**ADDENDUM NO. 1  
TO CONTRACT DOCUMENTS FOR THE  
CENTRAL AND PARALLEL EAST PIPELINES  
INSPECTION AND REHABILITATION PROJECT  
Project No. 95084002      Contract No. C0661**

**ADDENDUM NO. 2**  
**TO CONTRACT DOCUMENTS FOR THE**  
**CENTRAL AND PARALLEL EAST PIPELINES**  
**INSPECTION AND REHABILITATION PROJECT**  
**Project No. 95084002 Contract No. C0661**

**Attachment 4:**  
**Revised Drawings – C-32 to 6E-03**

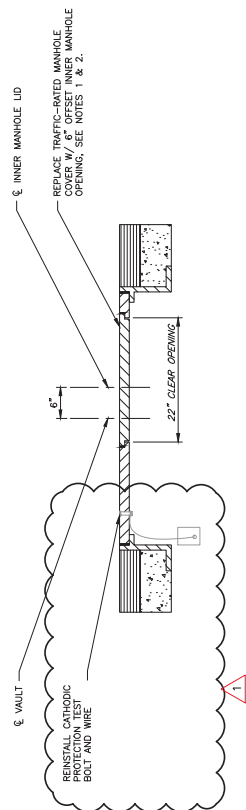
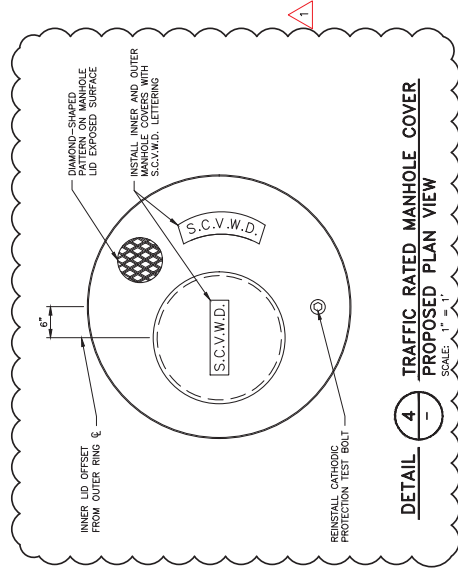
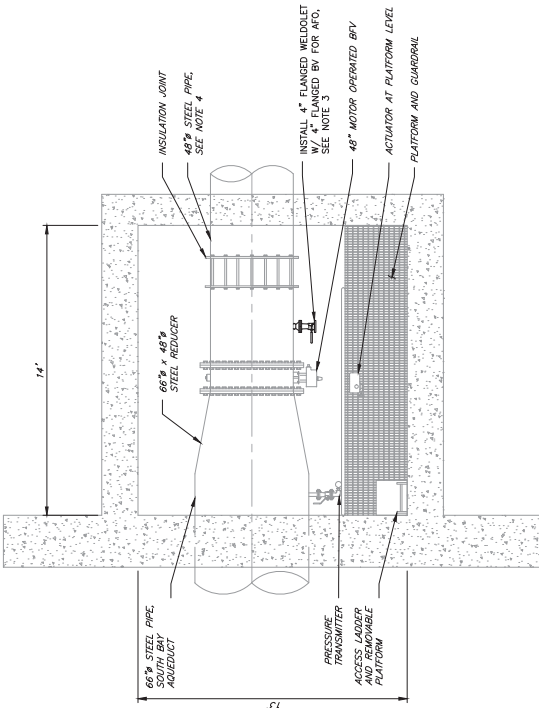
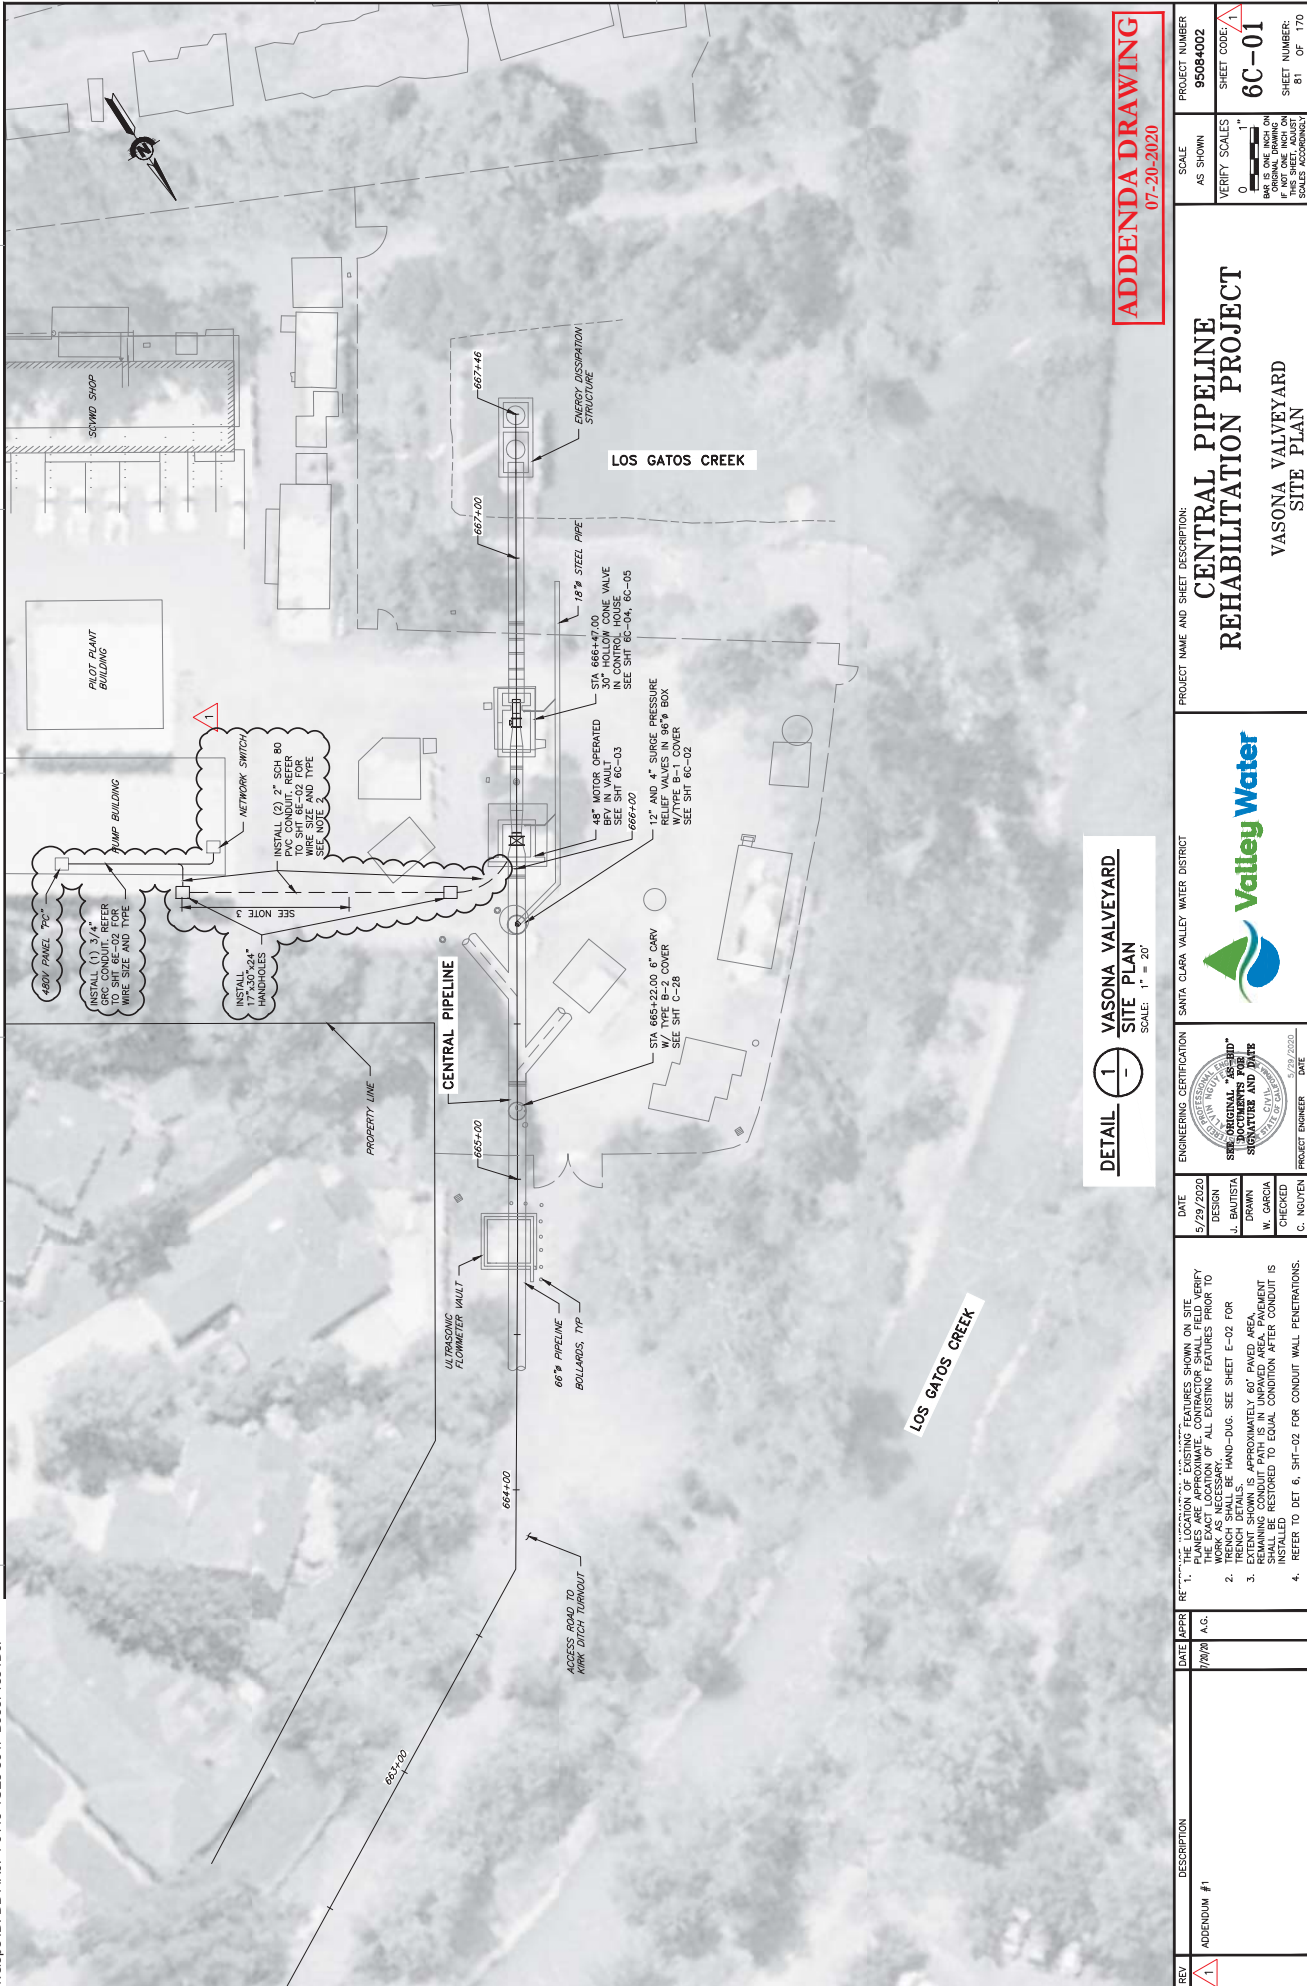
5. On Sheet C-01, **RELOCATE** the Piedmont Valve Yard callout on the plan and profile views to:

“STA -(00+21)  
CP 0  
PIEDMONT VALVE YARD  
LINE VALVE VAULT  
SEE C-32”

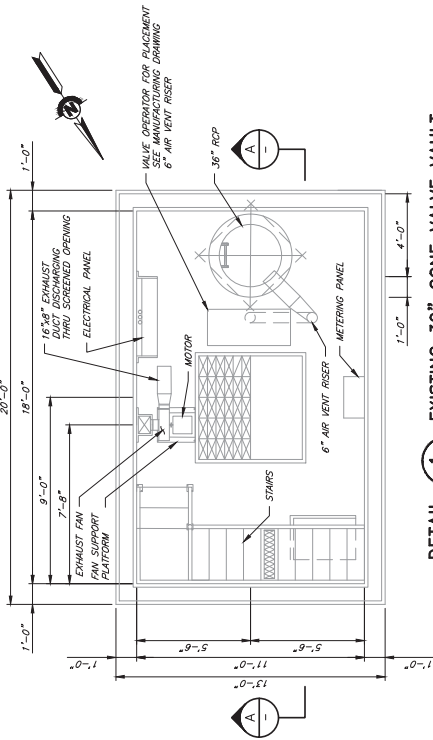
Per sheets 6E-02 and 6C-01, raceway is routed from the transformer to panel “PC” in the Pump Building. Please clarify the location of panel “PC” in the Pump Building.

On sheet 6C-01, conduit is shown to be installed between the pump building and the 48" motor operated BFV in vault. On this sheet, the conduit appears to be new and empty. On sheets 6E-02 and Detail 3 on 6E-03, the same conduits appear to be existing and contain wire. Please clarify the scope of the conduits and wire in this area. How many new conduits are required? Are we replacing the existing underground conduits to the pump building?

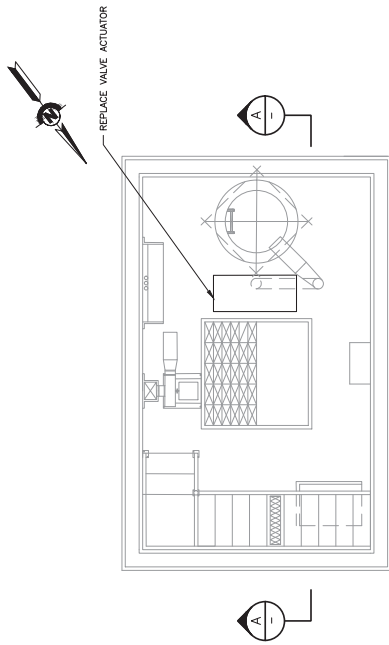
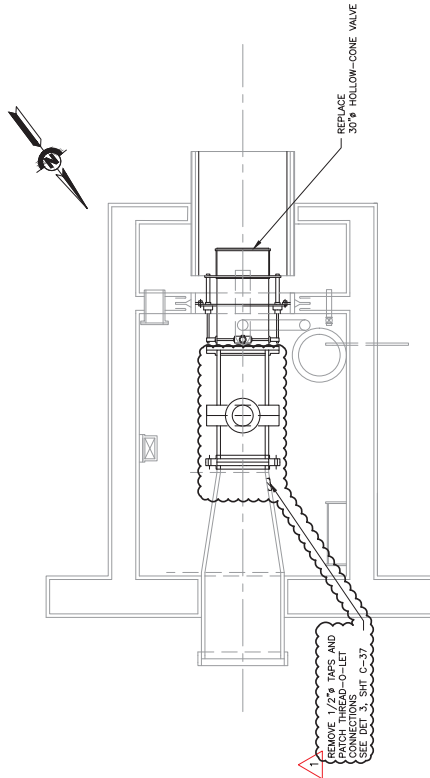
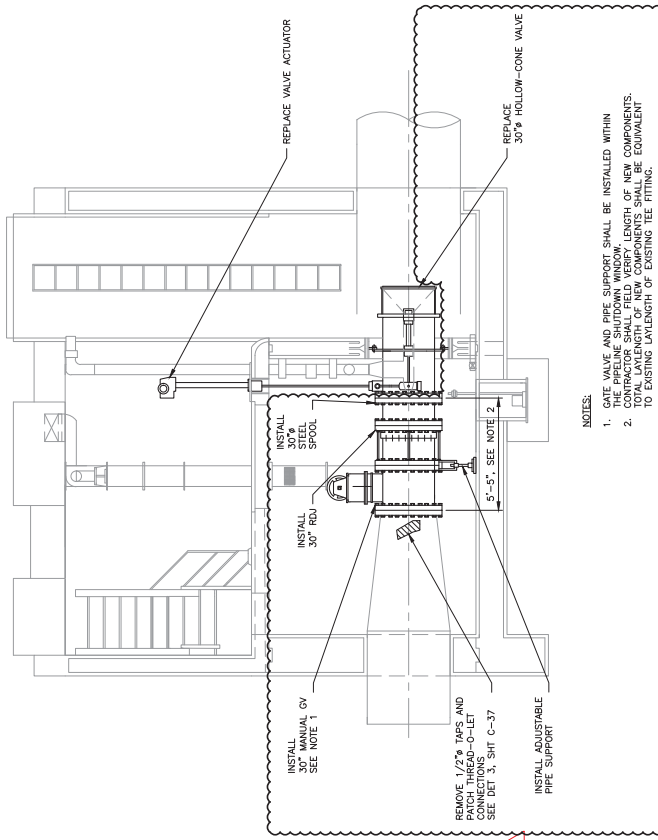
The replacement of the sleeve valve and cone valves may be completed after the pipeline is back in service. The 30" cone valve shall be isolated using the work shown in addendum drawing 6C-05.

- NOTES:
1. CONE VALVE AND PIPE SUPPORT SHALL BE INSTALLED WITHIN THE PIPELINE SHUTDOWN WINDOW. CONTRACTOR SHALL FIELD VERIFY LENGTH OF NEW COMPONENTS. CONTRACTOR SHALL FIELD VERIFY LENGTH OF NEW COMPONENTS TO EXISTING LENGTH OF EXISTING PIPE FITTING.
  2. CONTRACTOR SHALL FIELD VERIFY LENGTH OF NEW COMPONENTS TO EXISTING LENGTH OF EXISTING PIPE FITTING.

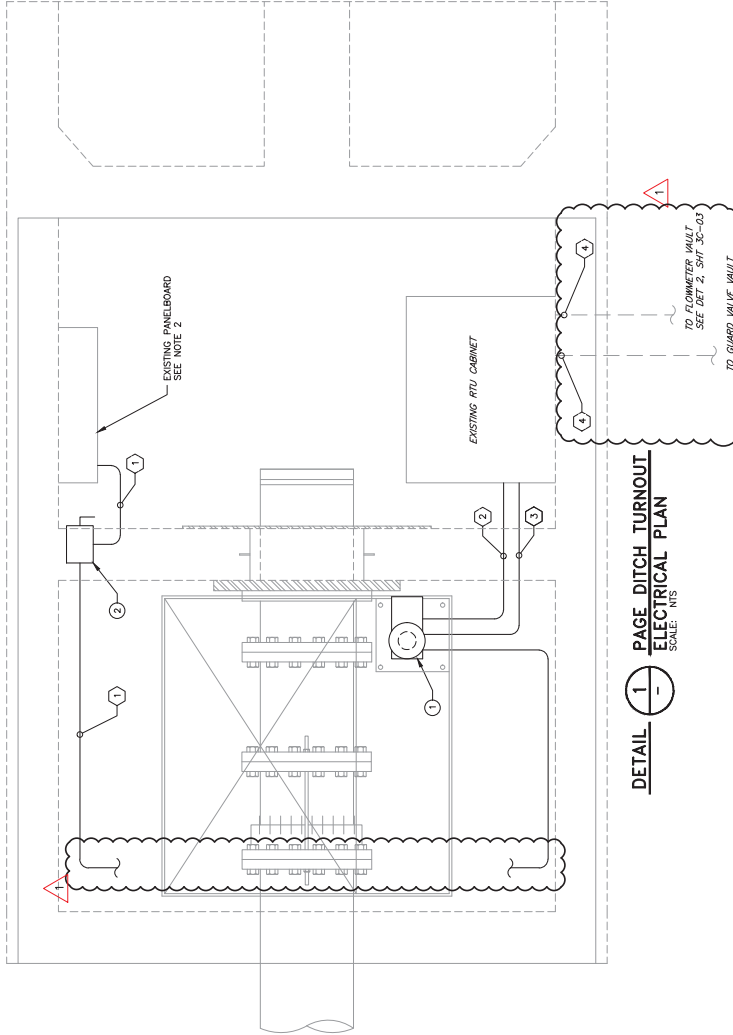
Precast concrete ground wells are indicated on sheets 2E-01 and 5E-01. Please clarify the specifications of the concrete ground wells.

Sheets 2E-01 and 5E-01 indicate that electrical metered service entrances are to be removed and replaced. Per Article 37.01, 1.04 A in the specs “For electrical service entrance installation or modification, the contractor shall coordinate with, and comply with, all PG&E requirements and the latest edition of the PG&E Greenbook.” What are the current specifications on the existing meters, panels, and power drops? What are the specifications and requirements on the new meters and power drops? Please confirm what work will be performed by PG&E.

Per Article 37.22, "general type of underground raceways shall be Schedule 40 Polyvinyl Chloride (PVC) conduit." On 1E-01, 2E-01 & 4E-01 the underground raceway is designated as Galvanized Rigid Conduit. Please clarify which type of conduit should be used.

Ground well shall be Oldcastle precast F08 Box or equal. Lid shall be reinforced concrete with etched label "Ground".

New meter panel shall have minimum 100A bus rating. New service disconnect shall be a circuit breaker, rated 40A minimum. Please refer to the PG&E Greenbook for all other requirements. PG&E will perform disconnection of the service prior to the work, and reconnection after completion. Contractor shall be responsible for all other modifications.

PROJECT NUMBER	95084002
SCALE	AS SHOWN
SHEET CODE	A
SHEET NUMBER	3E-01
SHEET NUMBER	92 OF 170

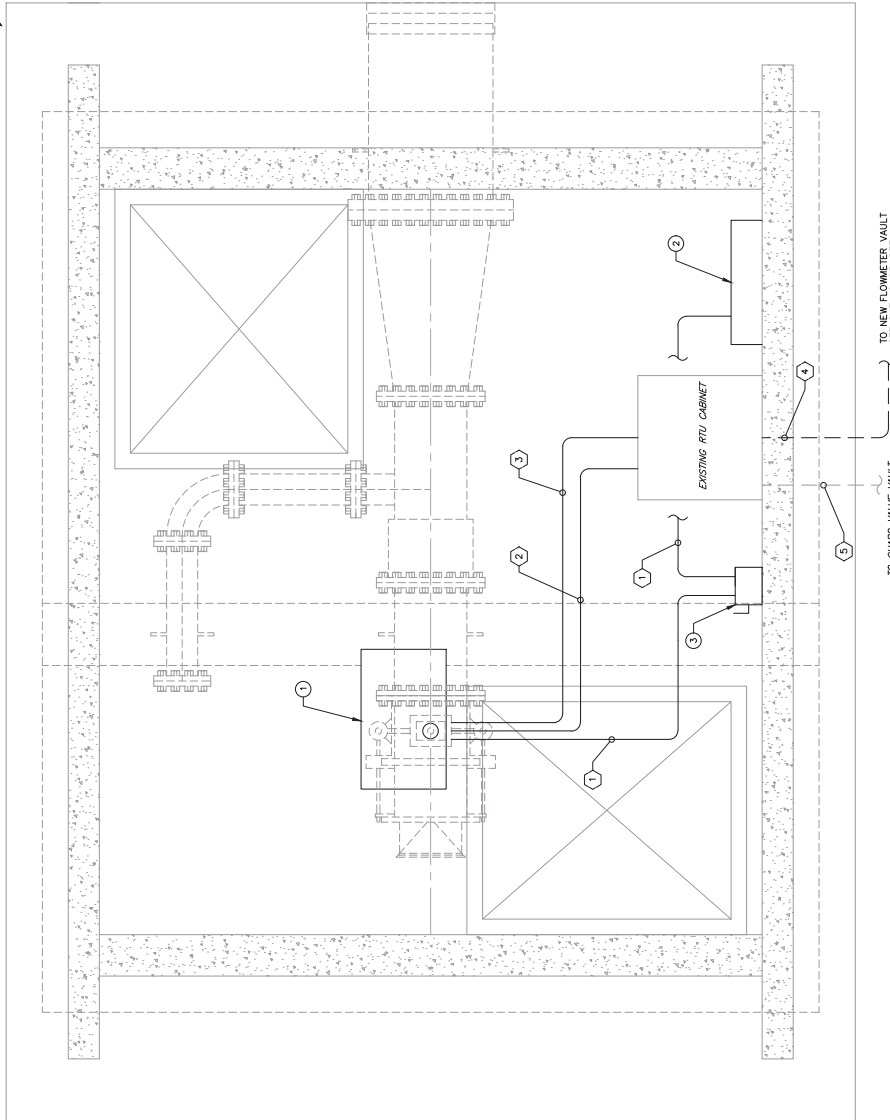
On sheets 3E-01 and 4E-01, there is raceway running from the Existing RTU Cabinets to a Guard Valve Vault. Are these conduits existing or new? If new, what size conduit shall be installed? Where is the Guard Valve Vault located?

Refer to the attached Addendum drawings for clarification. See 3C-01 and 4C-01 for guard valve vault locations.

PROJECT NUMBER: 95084002  
SHEET CODE: A  
SHEET NUMBER: 6E-02  
SCALE: AS SHOWN  
VERIFY SCALES: 0, 1", 1/2", 3/4", 1/4"  
IF NOT ONE INCH ON A SIDE, INDICATE SCALE ACCORDINGLY

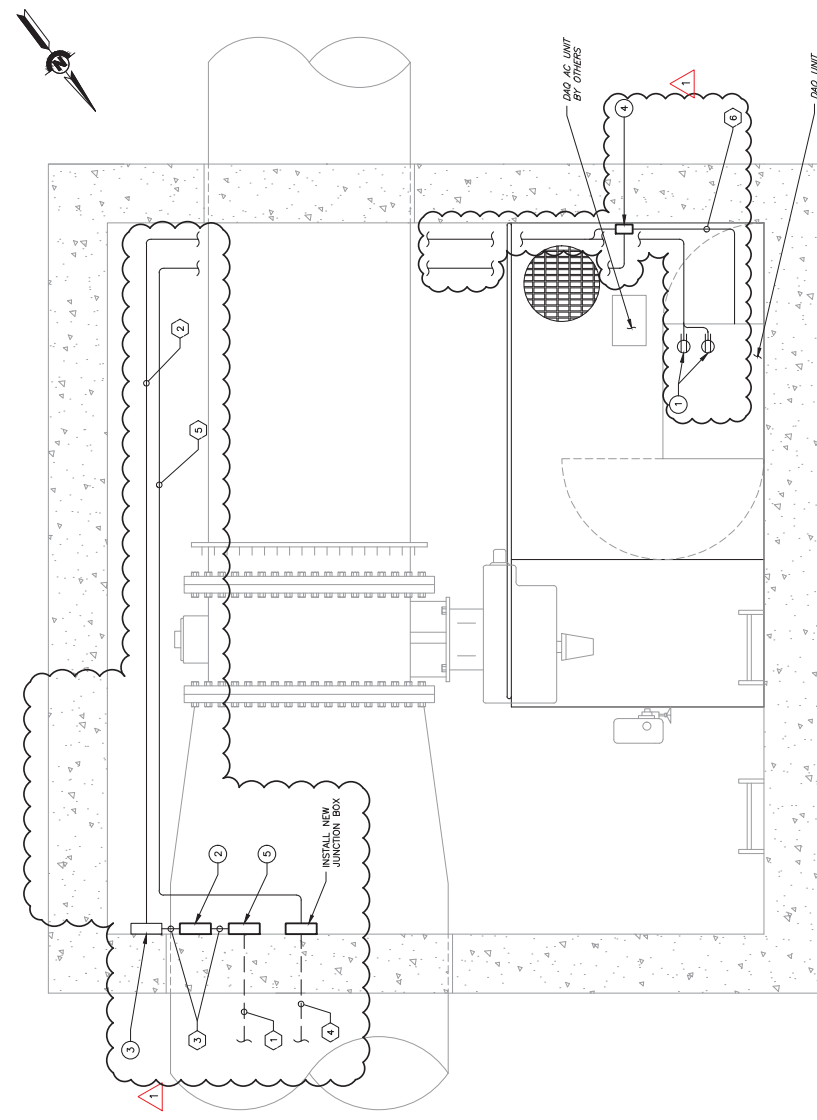
- NOTES:**
- INSTALL NEW 3P, 15A CIRCUIT BREAKER IN 480/277V PANEL "PC" FOR NEW SUBPANEL IN LINE VALVE VAULT. SEE GC-01 FOR PANEL "PC" LOCATION. APPROPRIATELY LABEL ALL CIRCUITS AND DISCONNECTS. DISCONNECT IT FROM THE MAIN ELECTRICAL PANEL AND DISCONNECT FROM THE MAIN ELECTRICAL PANEL. APPROPRIATELY LABEL ALL DISCONNECTS AND CIRCUITS.
  - INSTALL ALL TERMINATIONS AND CABLING FOR COMPLETE NETWORK COMMUNICATIONS. VERIFY ALL NETWORK COMMUNICATIONS CABLES ARE PROPERLY INSTALLED AND LABELLED. VERIFY ALL NETWORK COMMUNICATIONS CABLES ARE PROPERLY INSTALLED AND LABELLED. VERIFY ALL NETWORK COMMUNICATIONS CABLES ARE PROPERLY INSTALLED AND LABELLED.
  - ENSURE FIBER OPTIC CABLE BEND RADIUS IS NOT EXCEEDED. SEE GC-01 FOR CONTINUATION.
  - INSTALL (2) 120V OUTLETS WITHIN DAO UNIT ENCLOSURE FOR DAO UNIT AND DAO AC UNIT.
